North Eastern Regional Power Committee

**Sub: 91वीं संरक्षण समन्वय उप-समिति (पीसीसी) बैठक का कार्यवृत्त/ Minutes of 91<sup>st</sup> Protection Coordination Sub-Committee (PCC) Meeting**

### **91<sup>st</sup> Protection Coordination Sub-Committee Meeting**

**Date:** 20/08/2026 (Thursday)

### **B.8 GD at North Lakhimpur area of Assam on 19th Jun'26:**

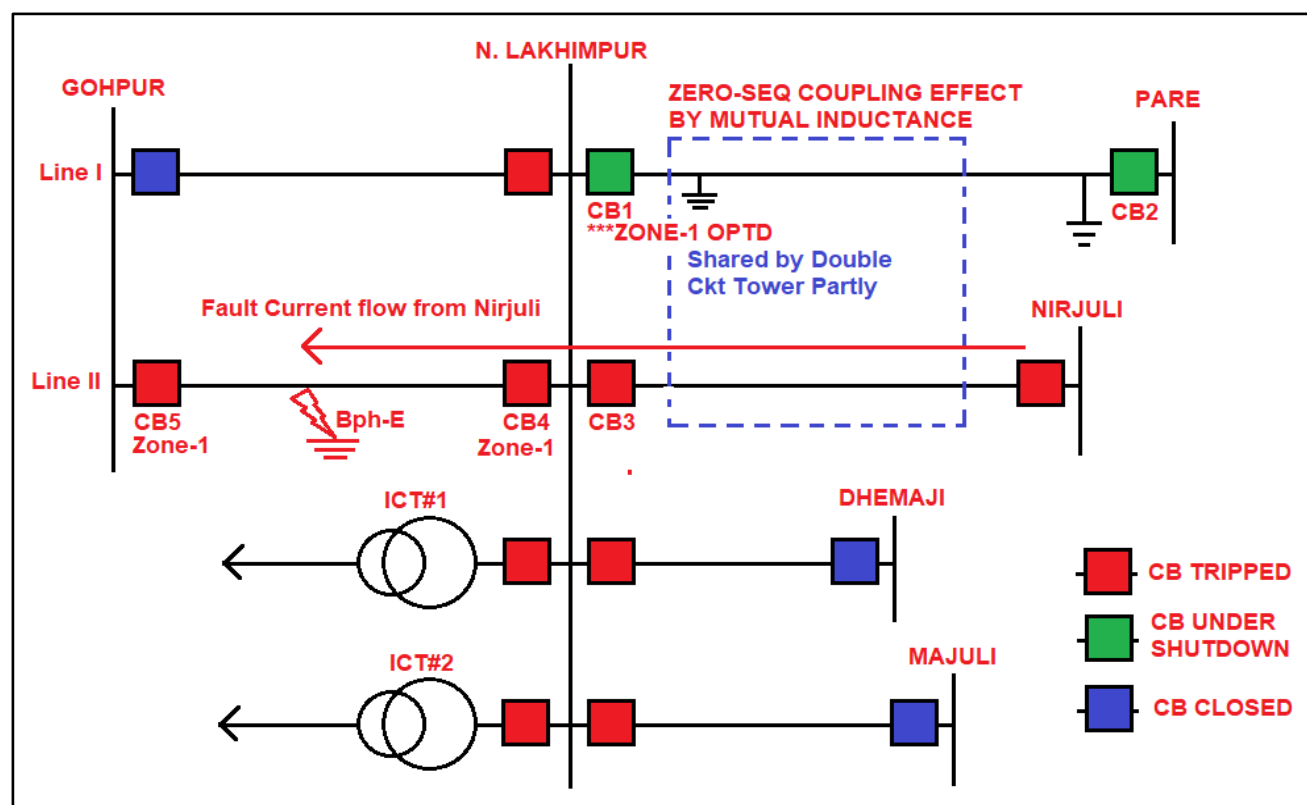
At 09:12 Hrs of 19-06-2026, due to tripping of 132 kV North Lakhimpur - Gohpur D/C & 132 kV North Lakhimpur–Nirjuli, blackout at occurred at North Lakhimpur, Majuli, Dhemaji and Silapathar.

### **B.9 GD at Along area of Arunachal Pradesh 9th July'26:**

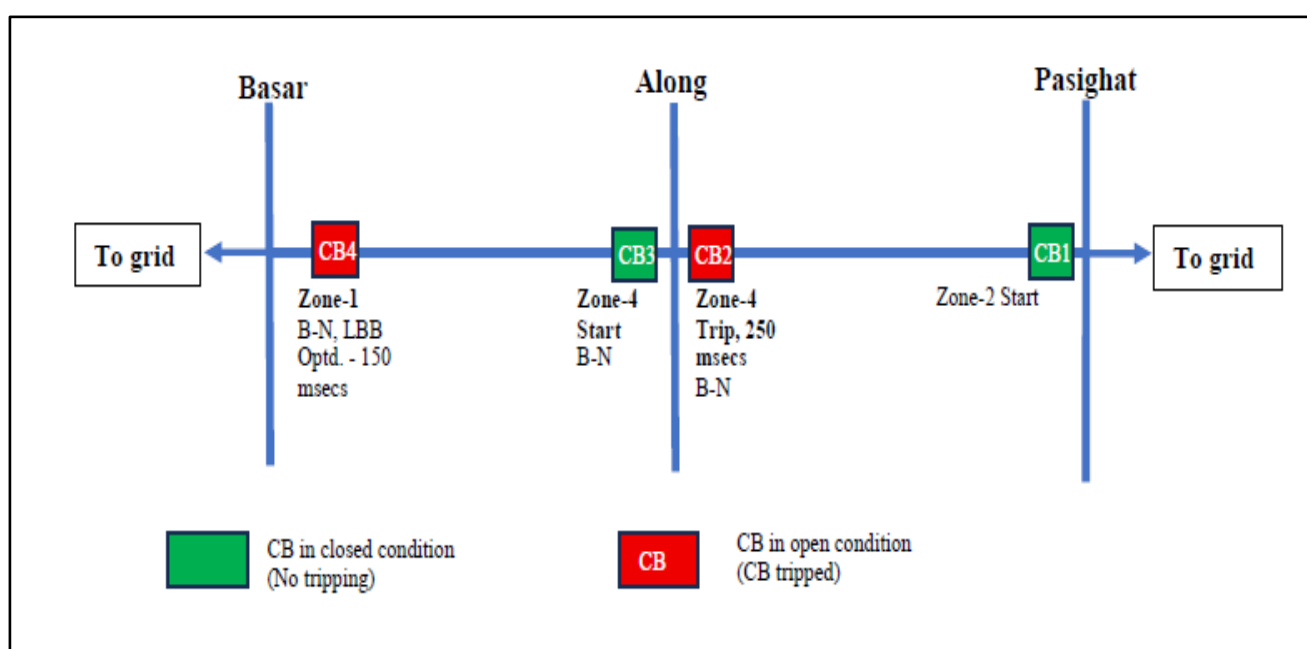
At 16:05 hrs on 9th July 2026, in order to commission the 132 kV TBC Bay at Along Substation, the 89T isolator of the ICT Bay was closed with due permission from SLDC. At 16:05 hrs, an insulator on the 132 kV transfer bus ruptured, resulting in a B-phase-to-neutral (B-N) fault on the 132 kV bus at Along Substation.

For the 132 kV Along-Basar line, Zone-4 Start was initiated at Along prior to tripping of the line from the Basar end by Zone-1 protection and subsequent LBB operation at Basar within 150 ms. The 132 kV Along-Pasighat line was isolated at the Along end by Zone-4 protection within 260 ms, resulting in the blackout of Along Substation. The Along-Pasighat line, however, remained energized from the Pasighat end.

The **132 kV transfer bus** at Along Substation was isolated, following which the substation was successfully re-energized through the main bus.

### **B.11 GD Tuirial HEP of NEEPCO due to frequent tripping of the 132 kV Kolasib – Tuirial line' July26:**

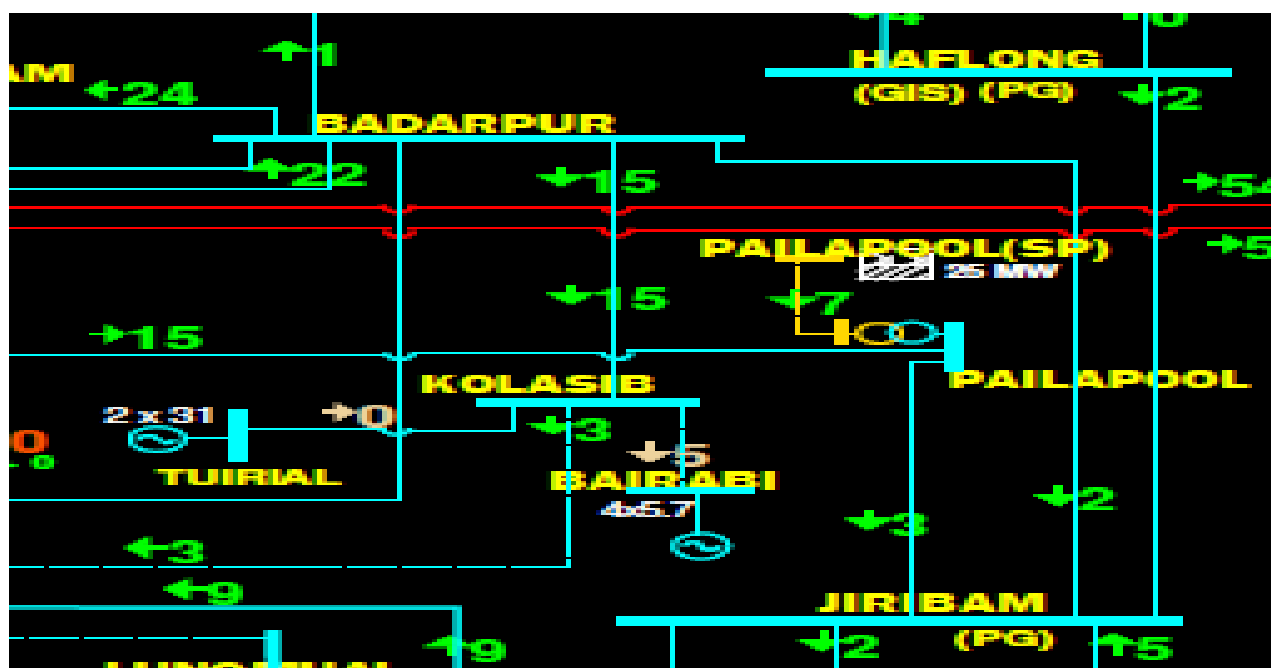
In July'26, the tripping of the said line observed 22 times at Tuirial end as summarised below-

1. Regular line maintenance to avoid outage of Tuirial generating plant.
2. Replace the backup relay at Kolasib for Tuirial line for which DR extraction is not possible. Hence, impacting the proper fault analysis.

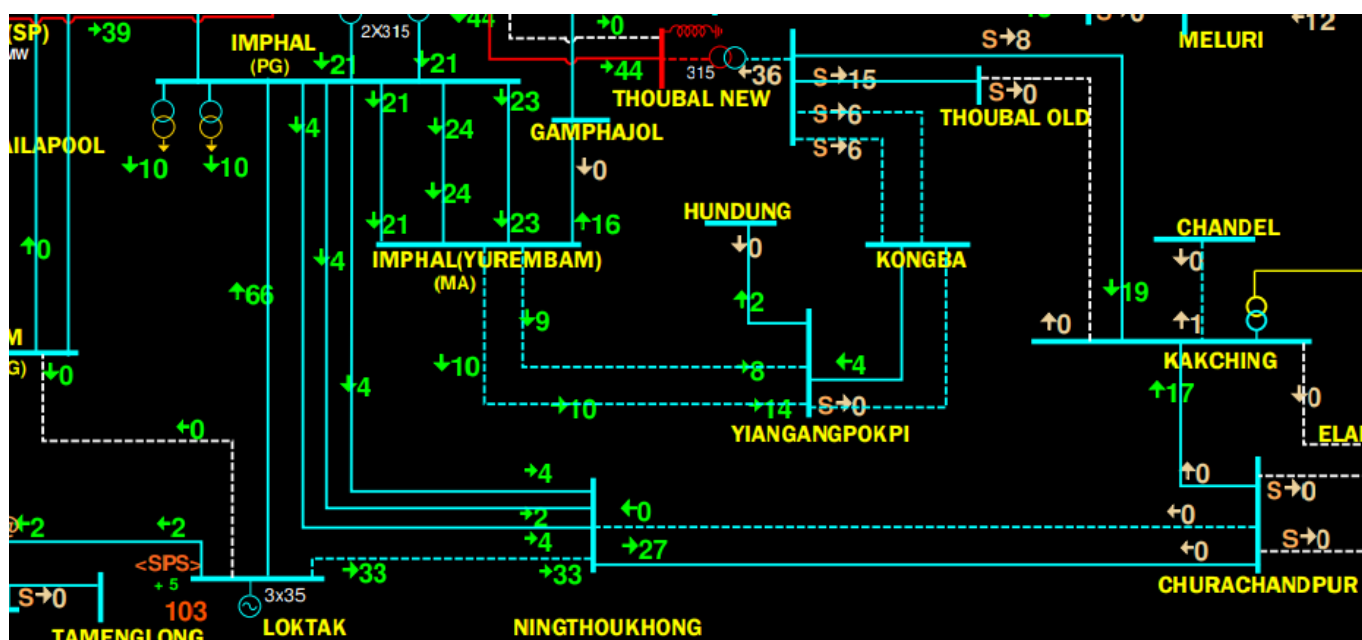
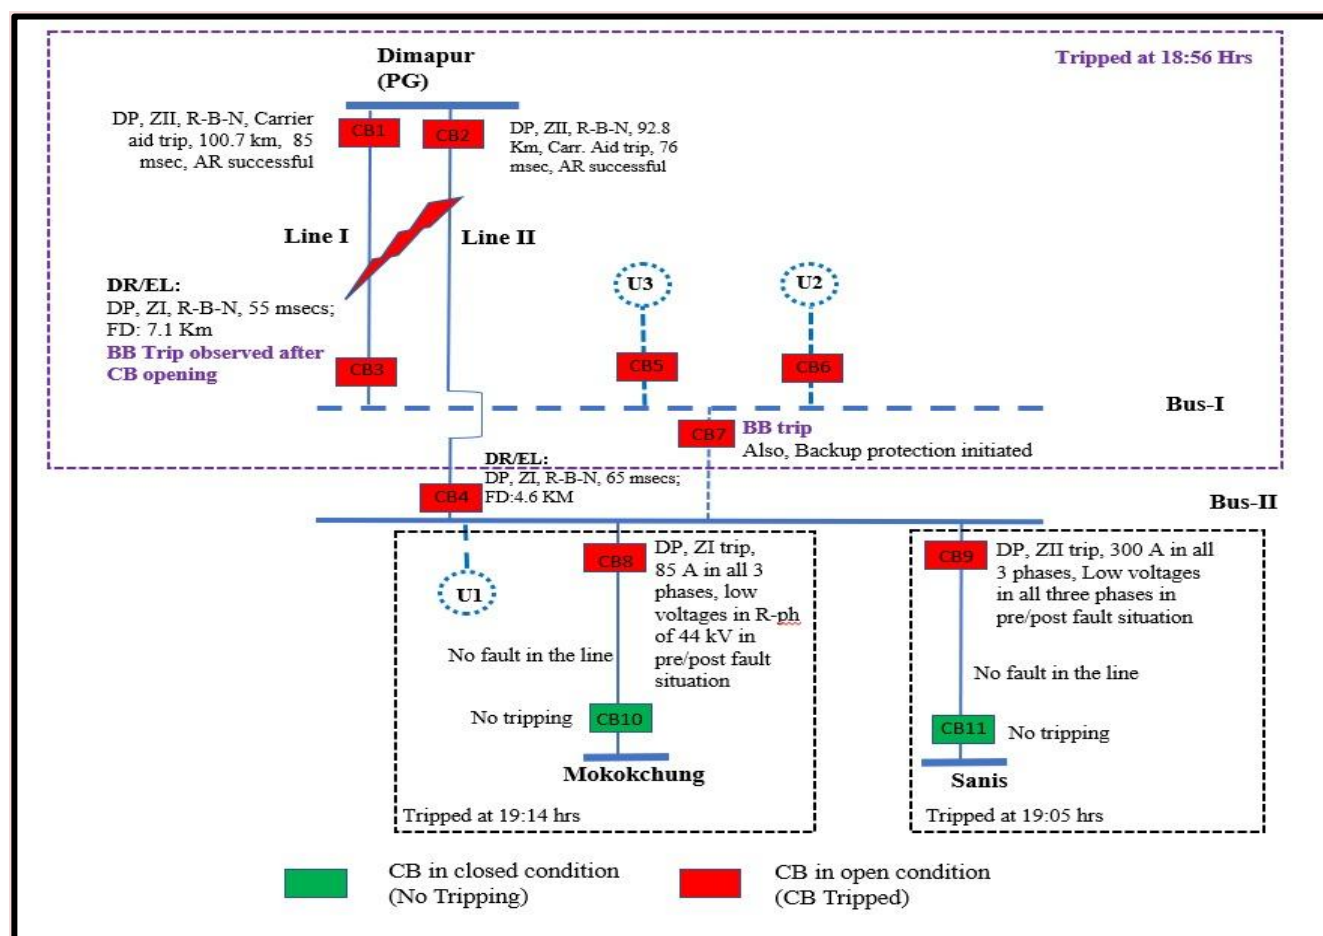
| Element Name | Line Length | Outage Duration (D.HH:MM) | Relay Indication | Remakrs |
|--------------|-------------|---------------------------|------------------|---------|
| 132 kV Imphal (PG) - Ningthoukong 1 Line | 27.5 KM | 0.00:38 | DP, ZIII, B-E, FD: 69.51 KM, 1.3 KA; Cleared in 866 msec | No Tripping; In>1 started for 866 msec        | <b>Fault beyond the line</b>                        |
| 132 kV Imphal(PG)- Ningthoukhong 2 Line  | 32.5 KM | 0.00:39 | DP, ZII, B-E, FD: 45.63 KM, 1.6 kA; Cleared in 305 msec  | No Tripping                                   | <b>Fault beyond the line</b>                        |

MSPCL informed that complete analysis of the fault could not be done due to non-availability of DR. He added that the fault location could not be ascertained.

However, MSPCL added, that they have raised the recording issue with the Siemens relay at Ningthoukhong.

Forum strongly requested MSPCL to taken necessary actions at the earliest.

**B.15 GD at P K Bari area of Tripura 17th July 2026:**

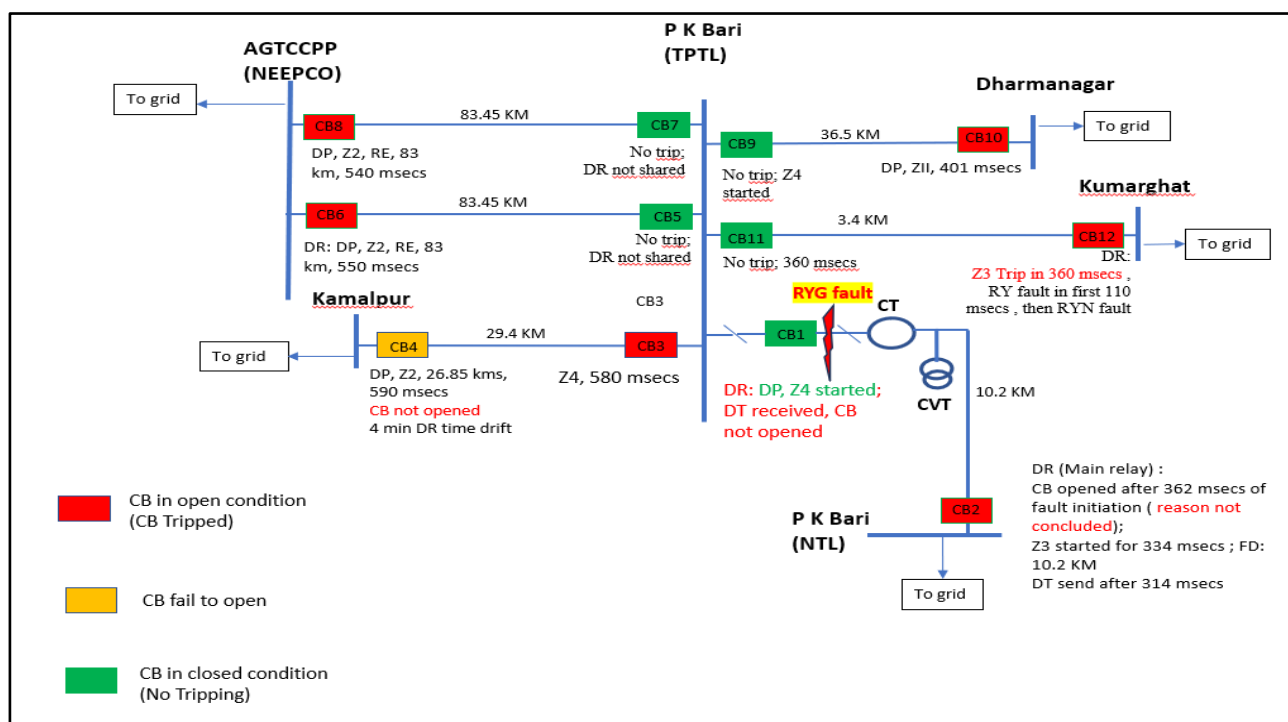
At 18:43 hours on 17-07-2026, all 132 kV lines connected to PK Bari (Tripura) substation tripped, resulting in the blackout of 132 kV PK Bari (Tripura) substation.

**Root cause shared by TPTL:** R-Phase AI tube link between 132kV CB and Line Isolator of 132kV P.K.Bari(ISTS)-P.K.Bari(TPTL) Line at P.K.Bari(TPTL) end got disconnected from CB as the connecting pad cracked open and resulted flashover.

#### C.1 GD at Doyang Power Station of NEEPCO and Sanis area of Nagaland on 1st July'26:

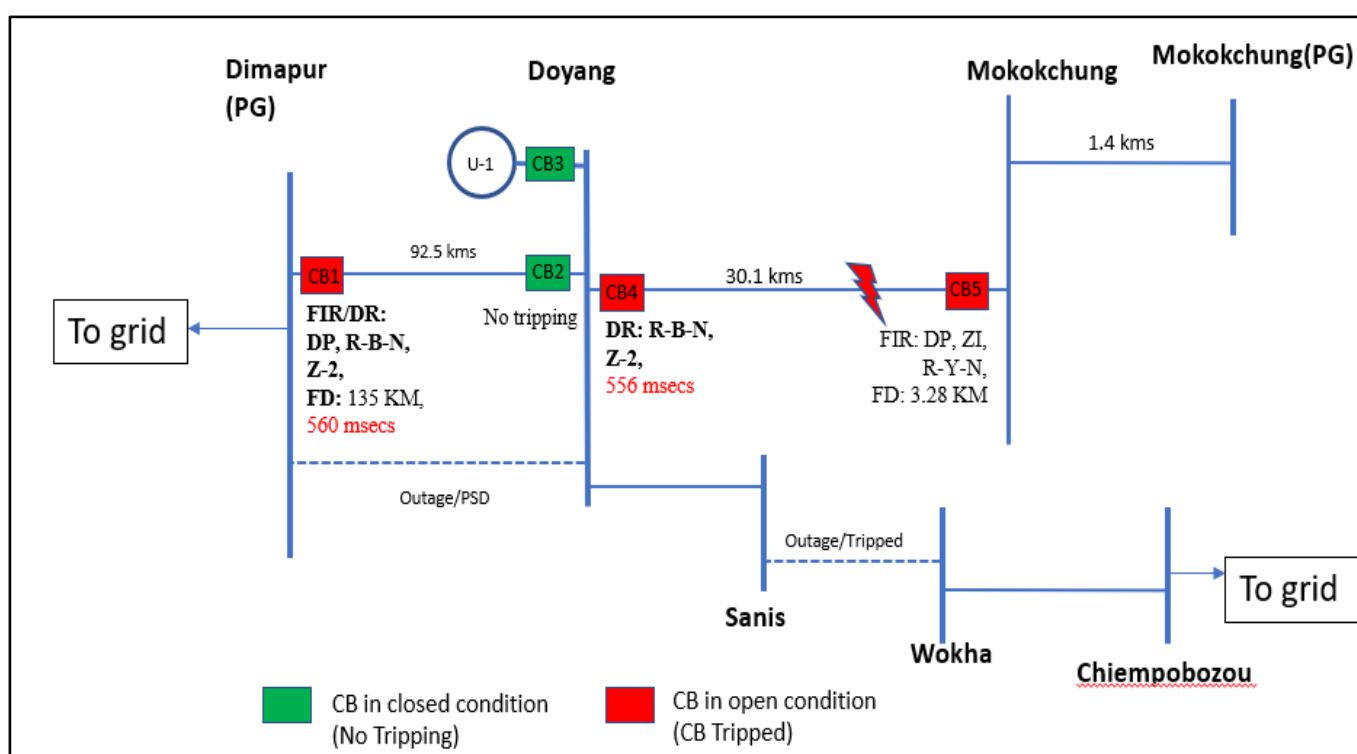
At 15:37 Hrs, LLG, metallic fault in 132 kV Doyang – Mokokchung line cleared from Mokokchung end in ZI protection and Doyang & Dimapur (PG) end of Mokokchung & Doyang -1 line within 560 msecs on operation of ZII protection resulted into GD at Doyang & Sanis area. Load loss: 1 MW & Generation loss of 18 MW recorded. Power supply was extended to Doyang power station of NEEPCO & Sanis area of Nagaland by charging 132 kV Dimapur - Doyang ckt 1 at 16:22 Hrs 17:17 Hrs of 01-07-2026.

In the pre-PCC GD discussion meeting held on 14.08.2026, NERPC suggested to change Z2 delay at Doyang for Mokokchung line to 400 msec and at Dimapur (PG) to 600 msec for Doyang line.

(Ref: Agenda B.19 | 90th PCCM | 23rd June 2026)

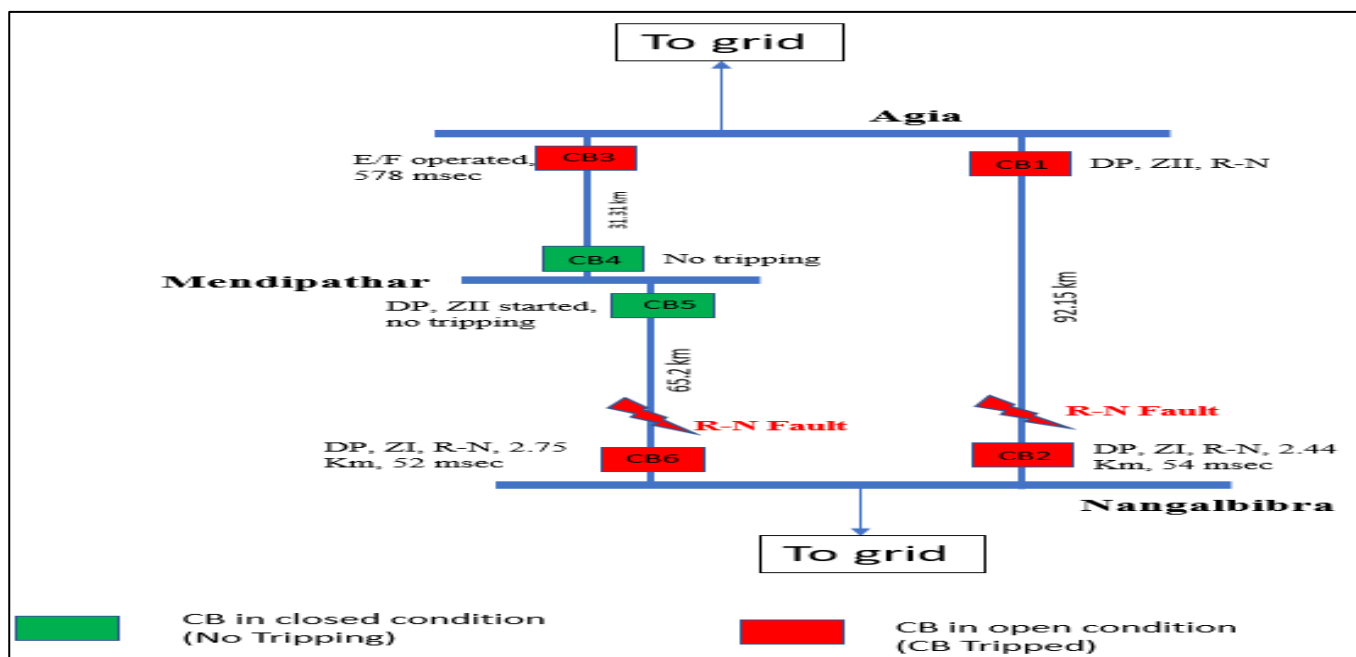
At 02:12 hrs of 04-06-2026, 132 kV 132 kV Agia-Mendipathar, 132 kV Mendipathar-Nangalbibra & 132 kV Agia-Nangalbibra Lines tripped leading to grid disturbance in Mendipathar area of Meghalaya power system. Load loss of 16 MW occurred.

As per DR analysis, Solid R-N fault (Ir-1.2 kA, In-1.4 kA) appears to be in 132 kV Agia Nangalbibra line at a distance of 2.44 Km from Nangalbibra which was cleared from Nangalbibra end (CB2) on ZI within 54 msec. ZII operated at Agia end (CB1). There was a subsequent fault in 132 kV Nangalbibra-Mendipathar line which tripped on ZI at Nangalbibra end (CB6) with a fault distance of 2.75 Km. ZII/ZIII started at Mendipathar end (CB5), however, prior to clearing of fault from Mendipathar end (CB5), 132 kV Agia-Mendipathar line tripped on operation of Earth fault from Agia end (CB3) within 578 msec.

- Relay at Mendipathar for Nangalbibra line to be tested.
- MePTCL to provide the ZII settings and EF settings, as mentioned above, to NERPC and NERLDC at the earliest.

MePTCL updated that the ZII settings at Mendipathar have been modified and new settings have been sent to NERPC and NERLDC.

(Ref: Agenda B.20 | 90th PCCM | 23rd June 2026)

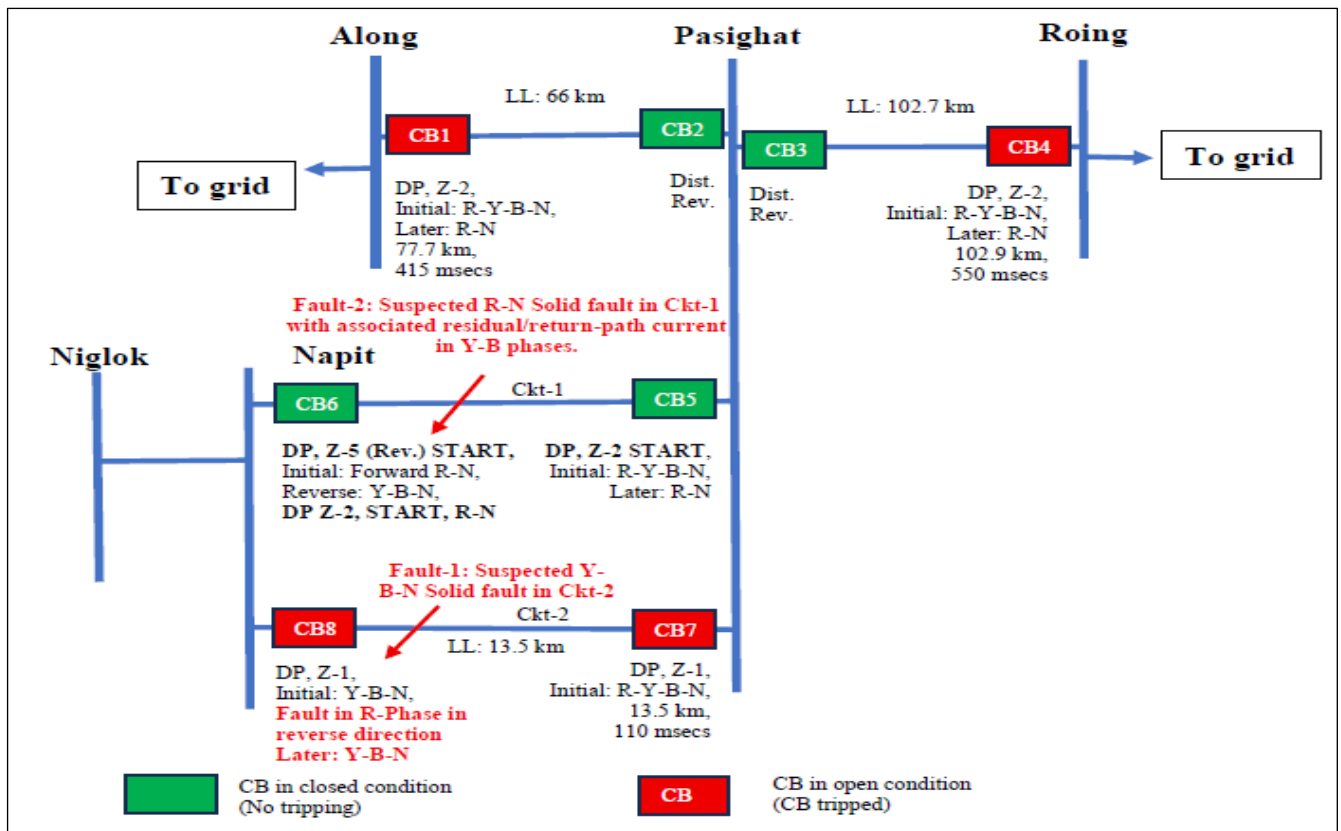
At 01:42 Hrs on 03-06-2026, 132 kV Along-Pasighat and 132 kV Roing-Pasighat lines tripped. Due to tripping of these elements, Pasighat, Napit and Niglok areas of AP Power System were isolated from NER Grid and collapsed due to no source available in this area. Load loss of 8 MW occurred.

A three-phase-to-ground fault (R-Y-B-N) appears to have occurred in the system connected at Pasighat. The fault initially persisted as a multi-phase fault for approximately 170 msecs, after which it evolved into a predominantly R-phase-to-ground fault.
